SERVICE BULLETIN

TS-430S INTERMITTENT PLL UNLOCK IN FM/AM

10-17-84

CONTROL UNIT (X53-1290-00)

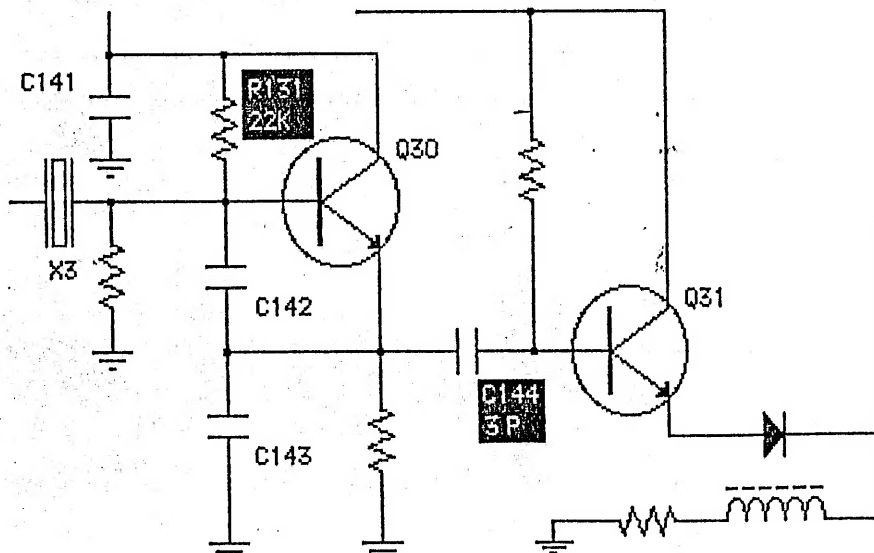
Some owners of the TS-430S have reported intermittent loss of Transmit and Receive when operating in the FM or AM modes, along with a loss of the Digital Display.

The cause of this may be due to a loss of the FM/AM Heterodyne Oscillator signal. Replacing the components listed below will correct most instances of this failure.

On the CONTROL UNIT (X53-1290-00) change R131 to a 22 K Ω 1/4 watt carbon resistor (RD14CB2E223J), and change C144 to a 3 pF 25 v disc ceramic capacitor (CC45SL1H050C).

No realignment is required.
